RCA-60-25-001-1: Install New Certification Label, R1T and R1S

Rivian is initiating a customer satisfaction campaign for some model year 2022-2023 R1T and R1S vehicles that were manufactured with a certification label that has the incorrect manufacturing date. Rivian will install an updated certification label. Rivian is launching this campaign for customer satisfaction and to ensure the quality of Rivian vehicles.

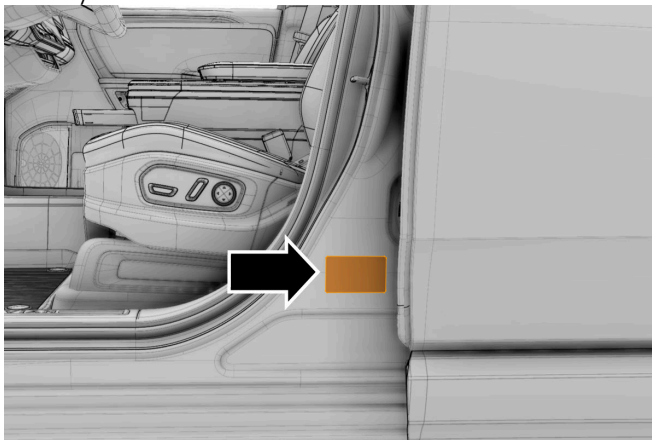
2. Identify the certification label.

! **Important:** There may be other labels nearby. The certification label contains the vehicle's gross vehicle weight rating (GVWR).

4. Apply the new label over the old one.
